**RFI 098
Pebble Project EIS**

Title/Subject:	TSF Options, Mine Area
Requestor:	AECOM
Date Transmitted:	10/16/2018
Recipient:	Pebble Limited Partnership (PLP)
Response Requested by:	10/22/2018
Rationale:	The PLP response for RFI 069 presented 26 potential TSF locations that were considered near the mine area. Details on feasibility and environmental considerations for these locations are necessary for alternatives screening purposes and for the USACE to evaluate the Least Environmentally Damaging Practicable Alternative (LEPDA).
Describe the Information Requested and Level of Detail:	<p>Please provide an evaluation of each mine area TSF location that was considered and explain why the NFK West and NFK East locations were ultimately selected. Include:</p> <ul style="list-style-type: none"> • Feasibility (technology, economics, logistics, common sense) • Availability (both now and ten years ago during project planning) • Environmental impacts (wetlands/Waters of the US, miles of streams, habitat, fill, dam safety, etc.)

The question presented in RFI 098 on TSF options in the mine area is addressed below:

TSF OPTION 9

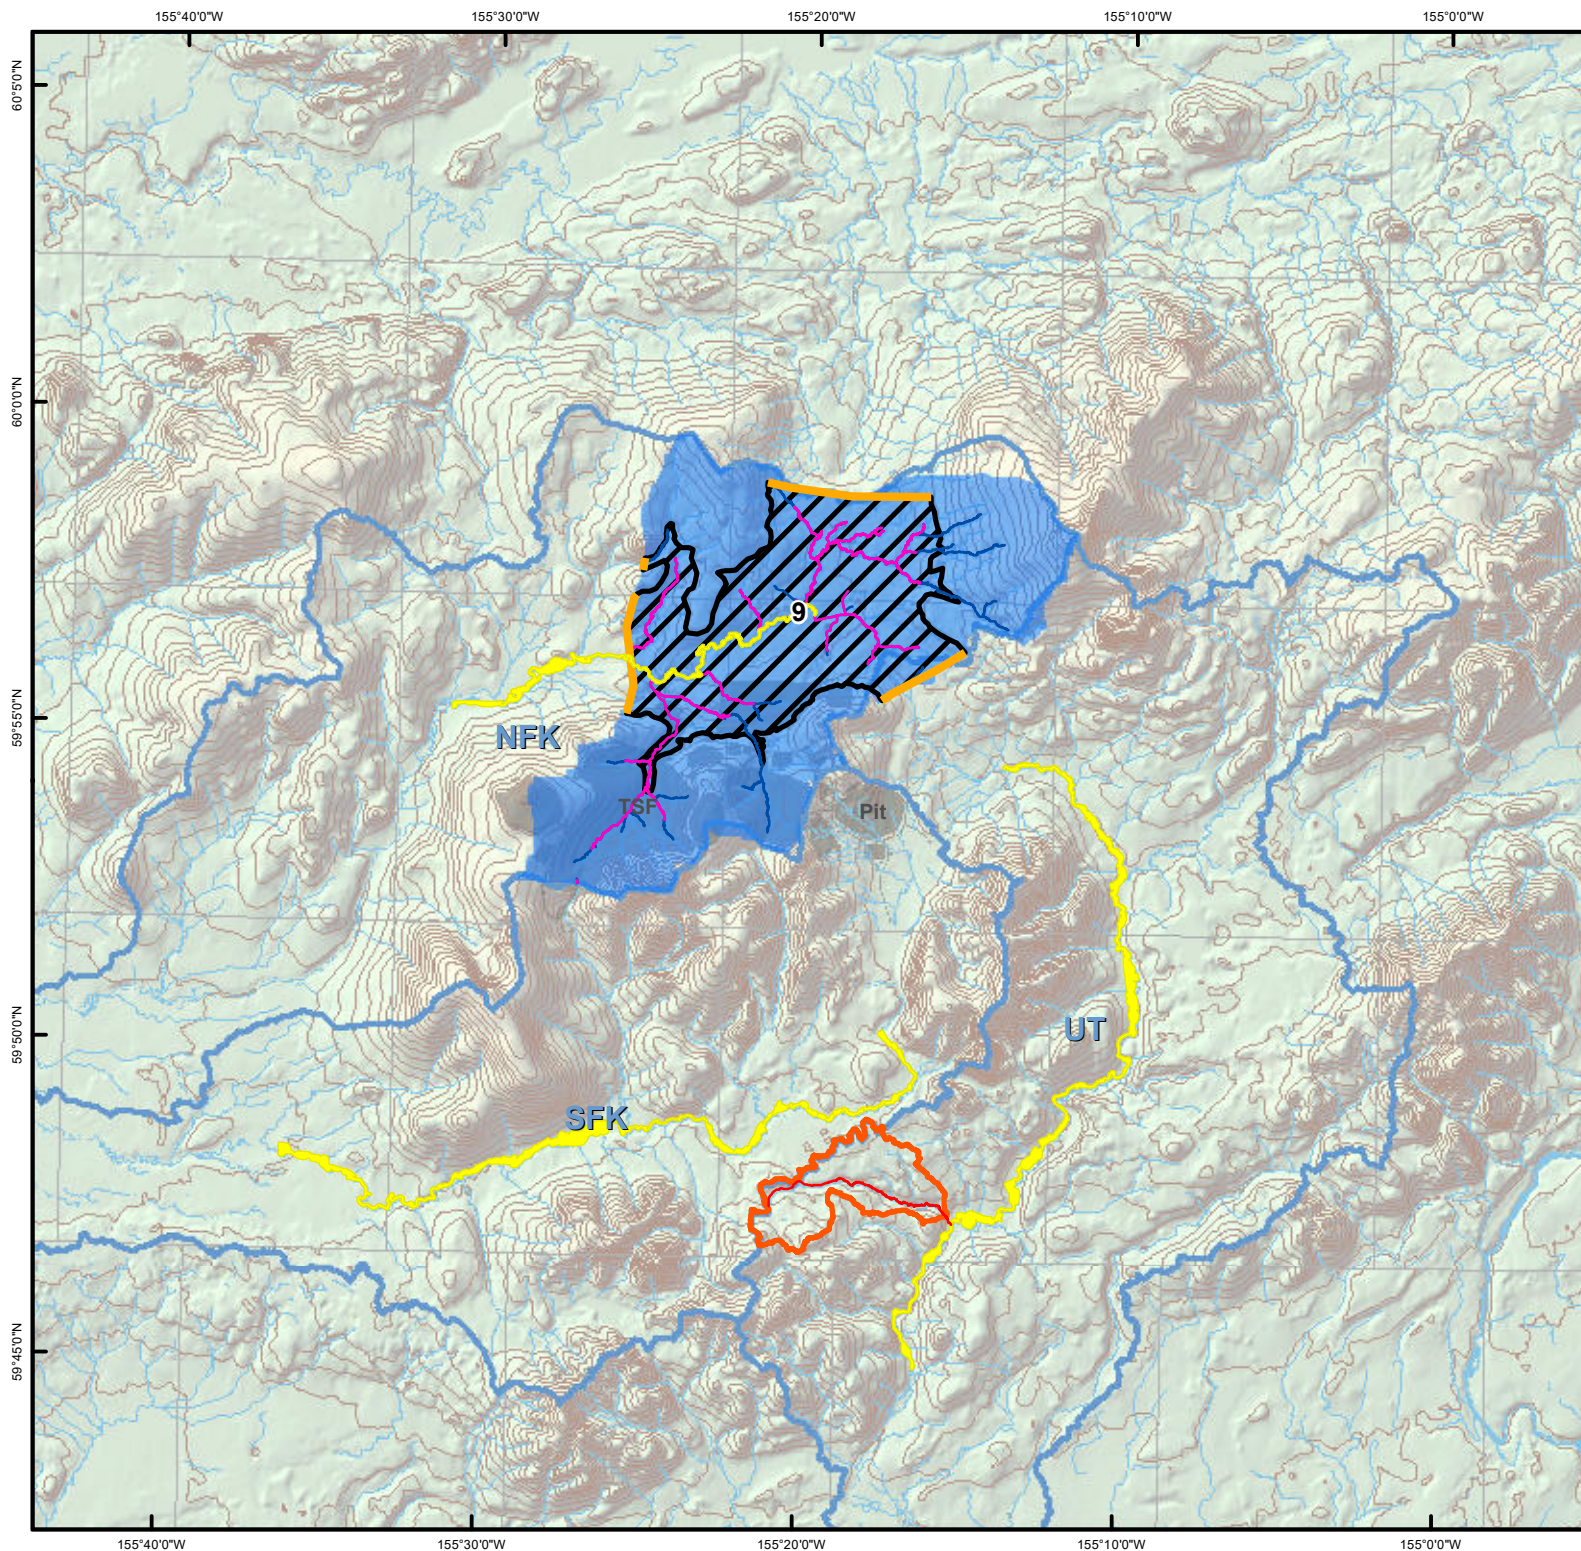
Option 9

- Has significantly larger impacts in all categories related to the footprint and stream impacts.
- The footprint has extensive overlap with MCO393.

TSF OPTION 10

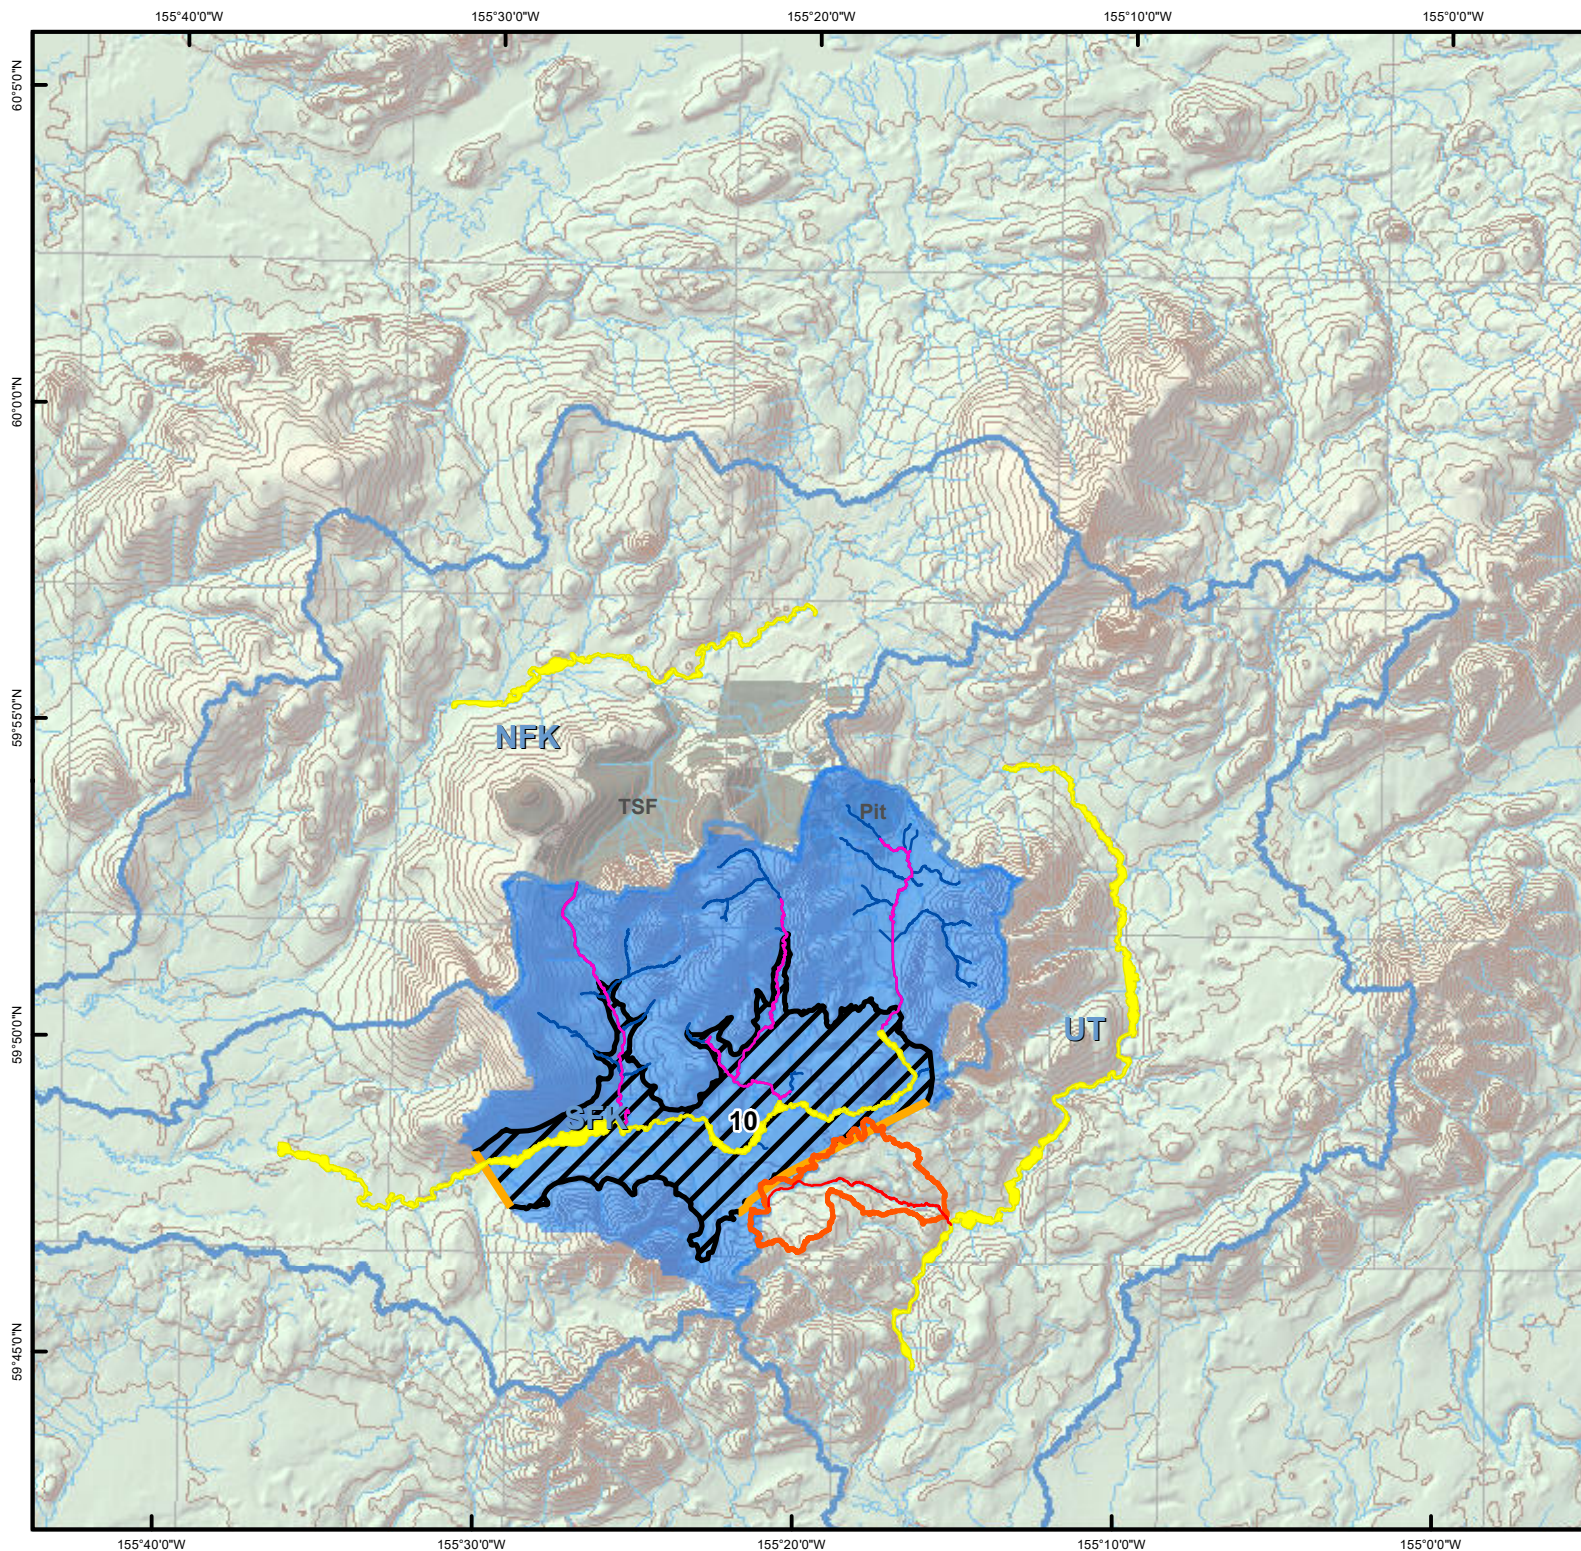
Option 10

- Has significantly larger impacts in all categories related to the footprint and stream impacts.
- Embankment location precludes effective collection of seepage from a flow-through embankment and would have the potential to impact groundwater flows into the SFK and UTC 119A drainages.
- Long distance for pumping of tails to western embankment.
- The footprint has extensive overlap with MCO393.

TSF OPTION 11

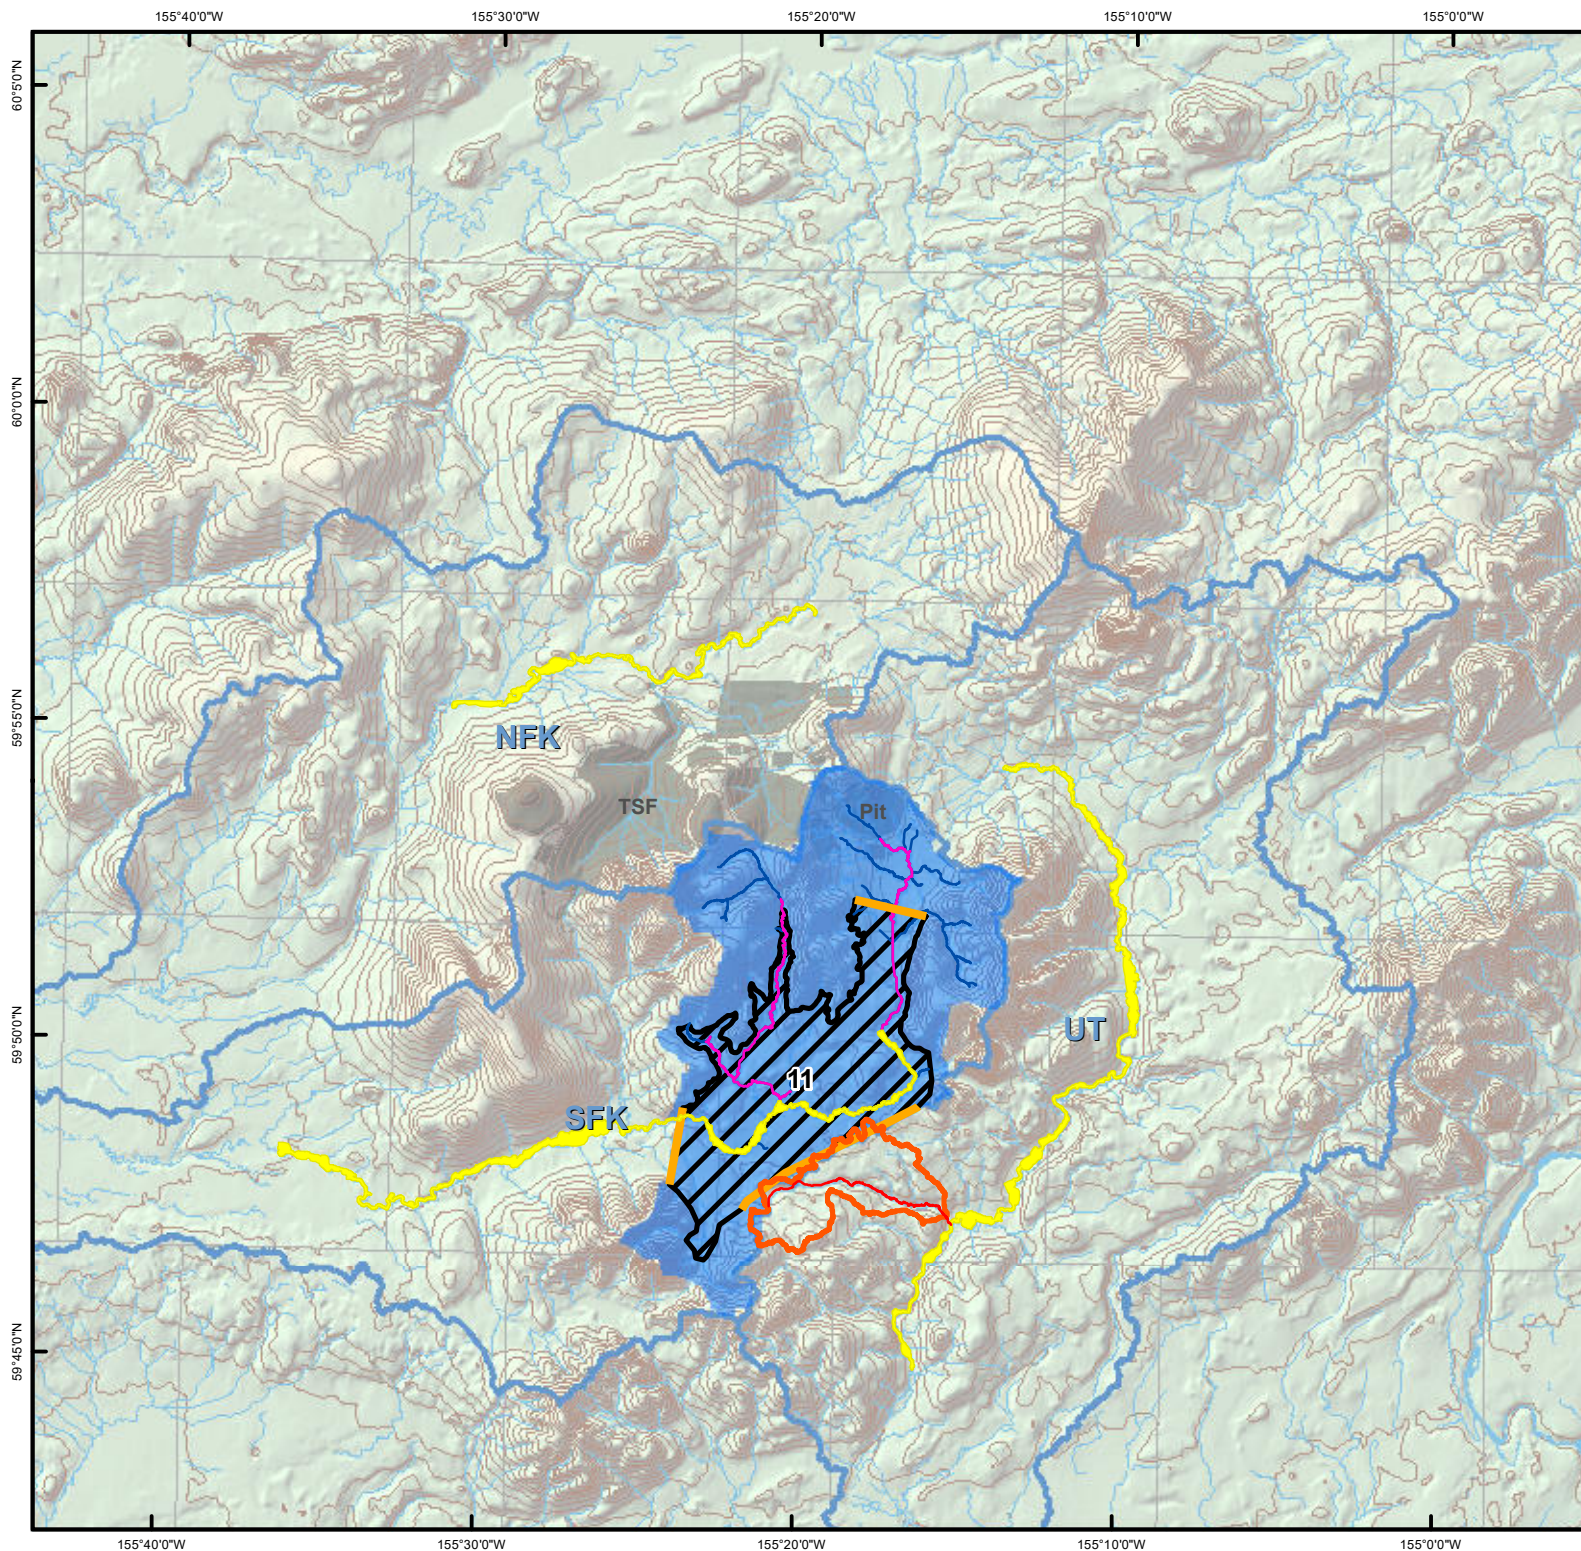
Option 11

- Fills slightly less mapped wetlands but has a much larger overall footprint and fills nearly three times as many stream miles.
- The impacted drainage basin and impacts to fish-bearing and anadromous streams are significantly higher.
- Embankment location precludes effective collection of seepage from a flow-through embankment and would have the potential to impact groundwater flows into the SFK and UTC 119A drainages.
- The footprint has extensive overlap with MCO393.

TSF OPTION 12

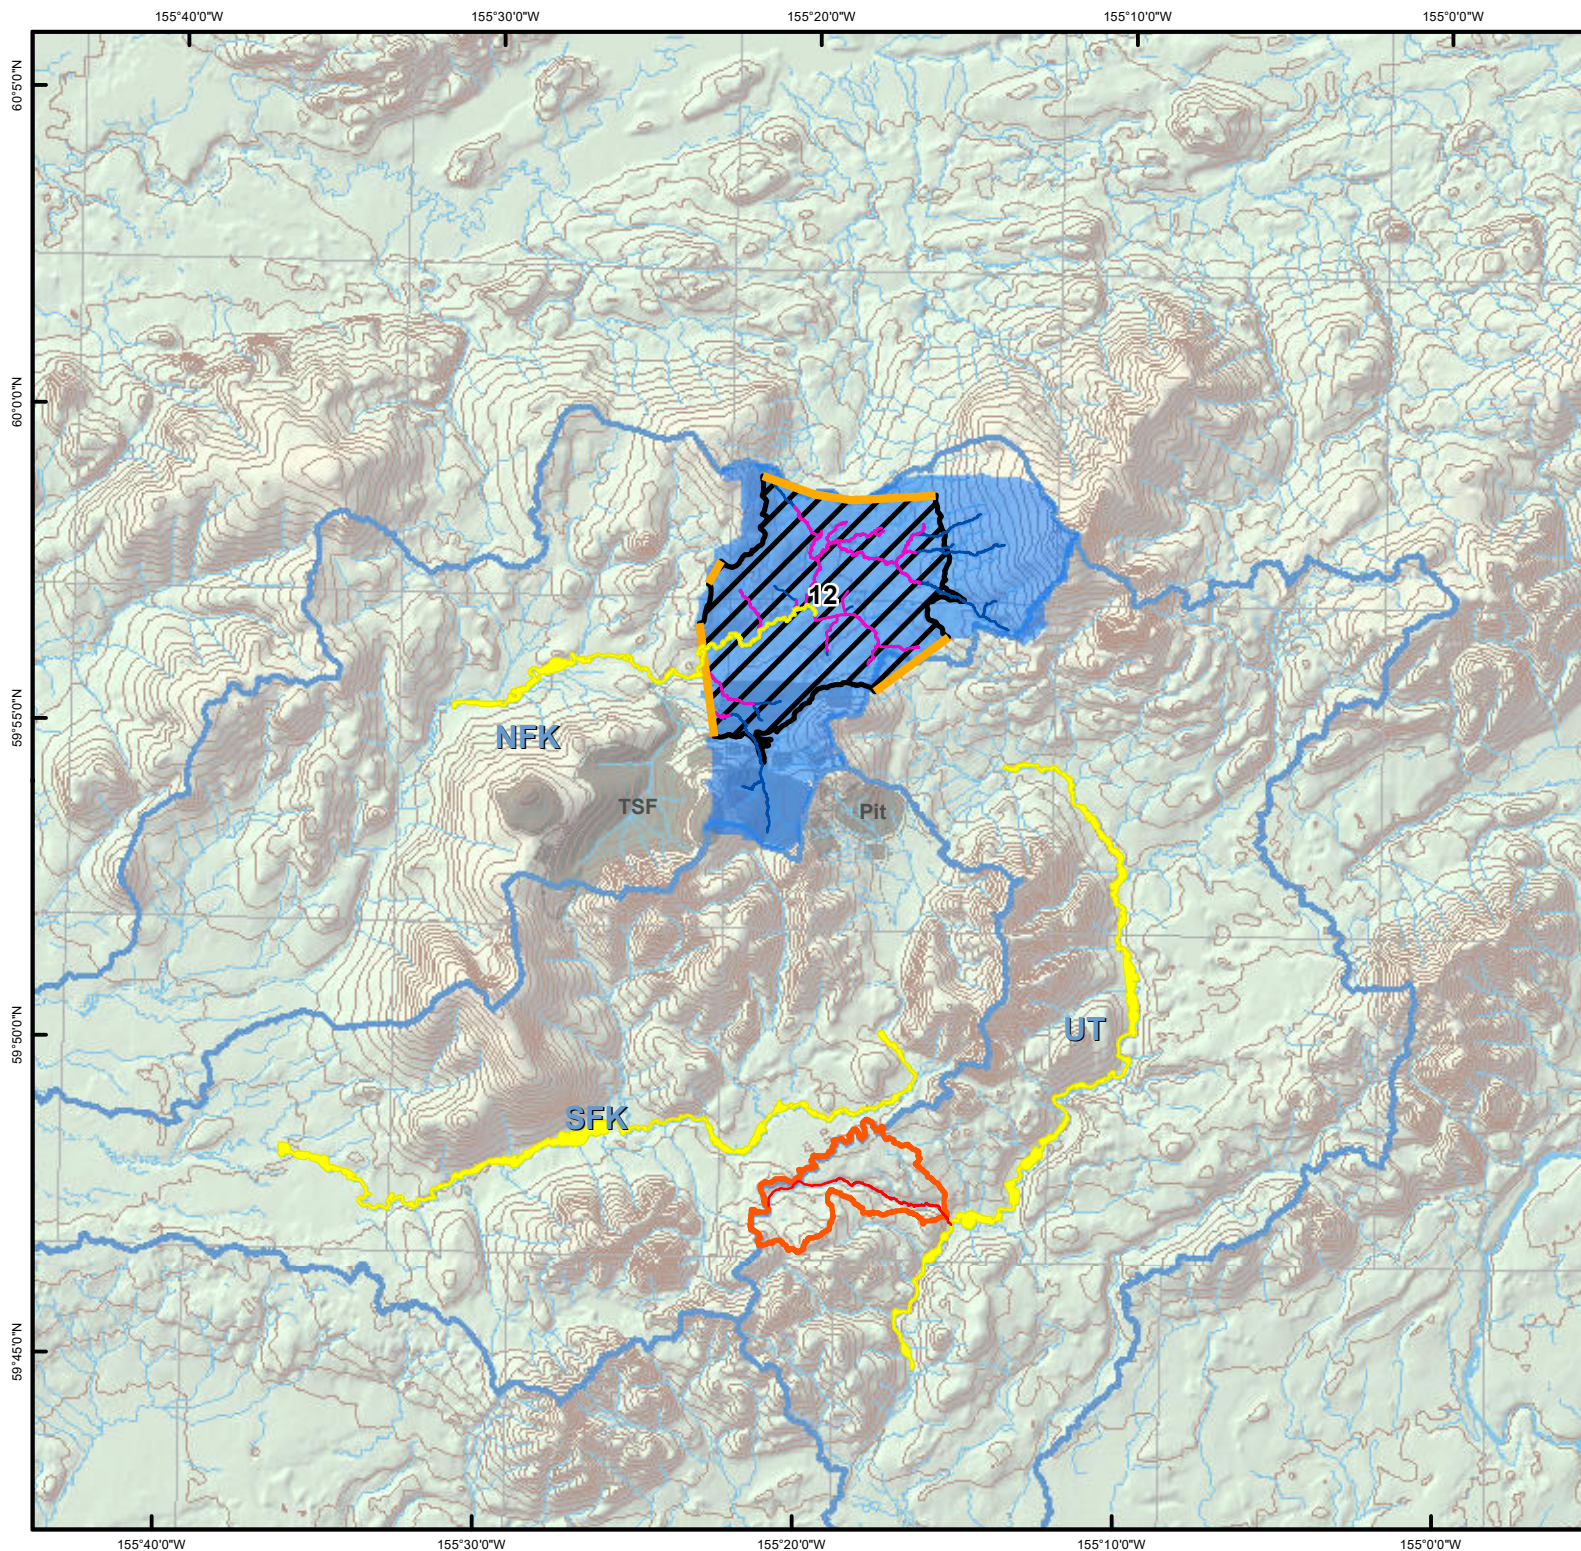
Option 12

- Has significantly larger impacts in all categories related to the footprint and stream impacts.
- The footprint has extensive overlap with MCO393.
